Memo

To: The Atherton Planning Commission
From: Sally D Bentz-Dalton, Town Arborist
CC: Radha Hayagreev, Senior Planner
Date: 6/14/23
Re: Tree Protection Zone (TPZ) Exception 183 Patricia

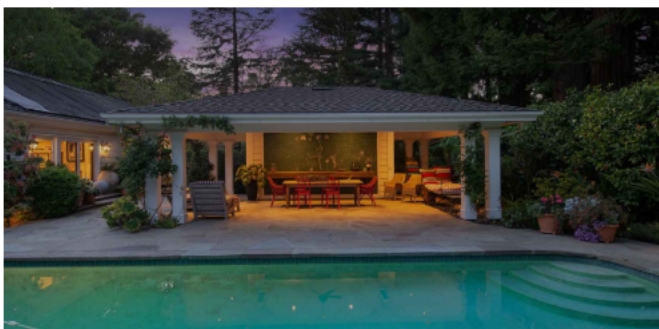
1. Tree #21 (Redwood), 38" DBH (estimated)
a. Exception to 6.52x (20'-8") away
b. % of encroachment: 3.4%
Proposed trellis, BBQ and utility area

2. Tree #22 (Redwood), 44" DBH (estimated)
a. Exception to 5.75x (21'-1") away
b. % of encroachment: 6.7%
Proposed trellis, BBQ and utility area

3. Tree #25 (Redwood), 28" DBH (estimated)
a. Exception to 9.60x (22'-5") away
b. % of encroachment: 0.1%
Proposed trellis

4. Tree #26 (Maple), 32.1" DBH
a. Exception to 6.54x (17'-6") away
b. % of encroachment: 3.0%
Proposed trellis

2 (E) POOL AND CABANA (TO BE REMOVED)
L-1.01 SCALE: N/A

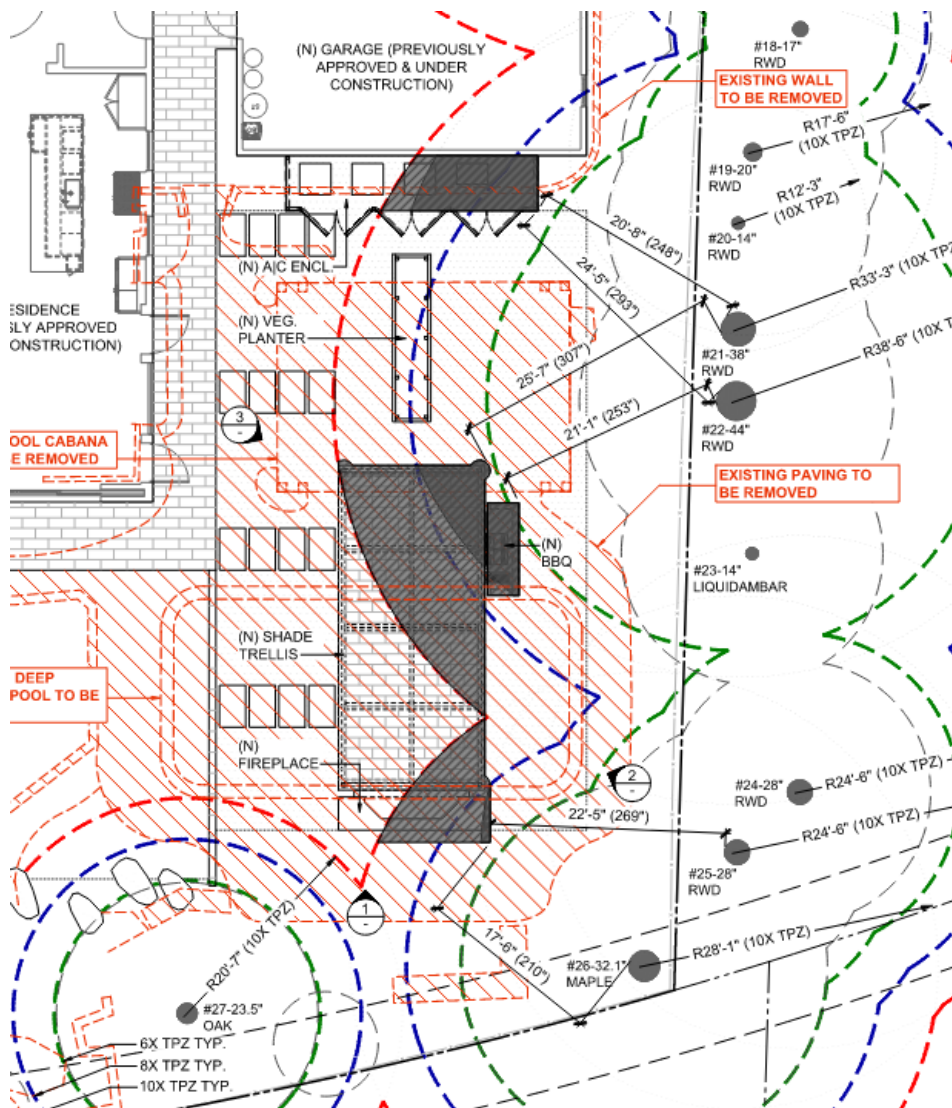
The applicant is proposing to install a new shade trellis and BBQ. The existing location has a pool house, cabana, pool and paving. The applicant is proposing to demo the cabana, pool and much of the existing paving. The existing pool and cabana do not meet the current code.

Tree #21 – The current cabana is 15.9' away. The proposed trellis is 25.7' away.

Tree #22 – The current cabana is 15.10' away. The proposed trellis is 21' away. The existing paving is 18.9' away. The paving is proposed to be removed.

Tree #25 – The existing paving is 11' away. The existing pool is 17' away. The new trellis is proposed to be 22.5' away with no paving or pool.

Tree #26 – The current paving is 10.11' away. The trellis will be 17.6' away with no paving. Demoiing the pool with add more soil volume.

In all cases the TPZ zones are extending which means the trees will have more soil volume and less compaction. The disturbed area is being proposed to disturb less root zone for the trees.

In conclusion **I can recommend the below 4 requests** because the proposed trellis is further back from the existing conditions. Because of the existing paving there are most likely less roots located in the proposed area. Redwood species have a good tolerance to construction impacts. For the Silver Maple removing the pool and paving and adding irrigation the health of the tree will improve.

- Hand excavation only within 8x TPZ. This includes demo of the paving is required to be done by hand.
- The area under the drip line of trees should be thoroughly irrigated to a soil depth of 18" every 3-4 weeks during the dry months.
- Mulch should cover all bare soil within the tree protection fencing. This material must be 6-8 inches in depth after spreading, which must be done by hand. Coarse wood chips are preferred because they are organic and degrade naturally over time.
- Sufficient tree protection for the Silver Maple and neighbor's Redwoods during demo and trellis install.
